ADDENDUM NO. 1 - TO ALL PLAN HOLDERS OF RECORD

Maine-Endwell Central School District
2022 Capital Improvement Project – Phase 5
Homer Brink Elementary– SED # 03-11-01-06-0-001-023

King + King Project #23-44-7956

AD1-A.01

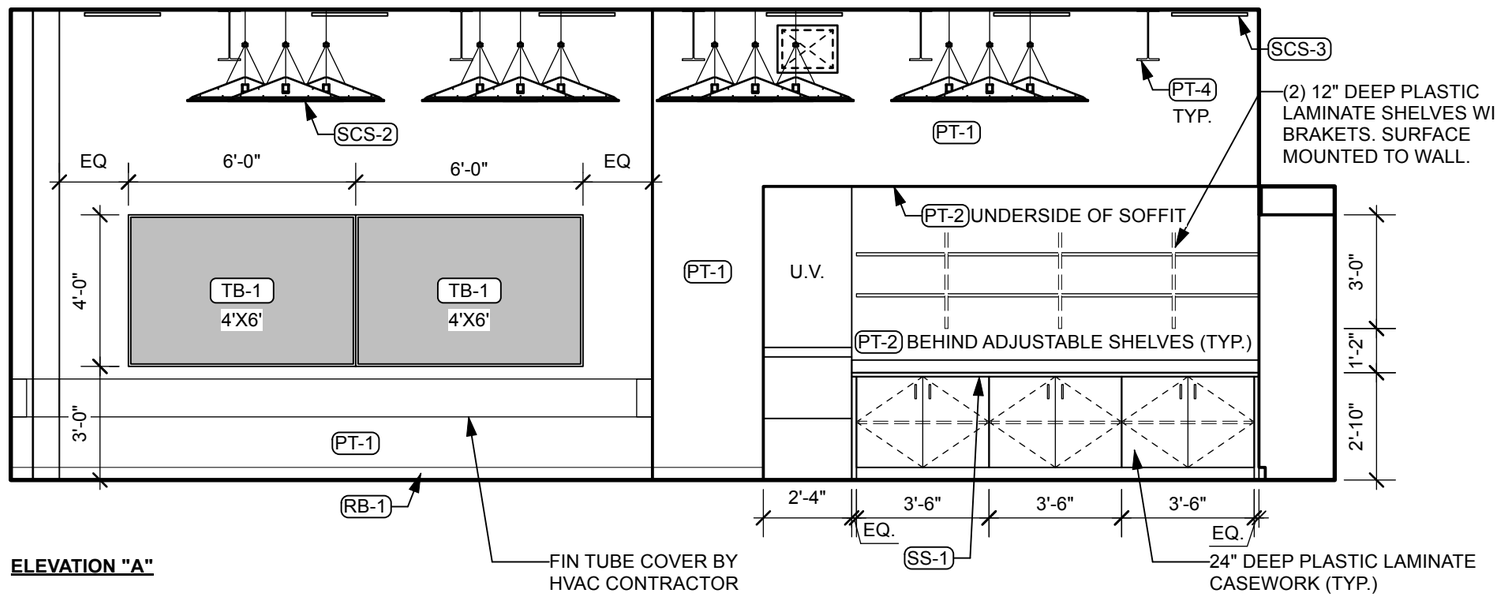
a. Refer to D2 INTERIOR ELEVATION – MUSIC G17 – ELEVATION 'A' and REPLACE in its entirety with the revised MUSIC G17 – ELEVATION 'A' in AD1-A.01 attached to this addendum.
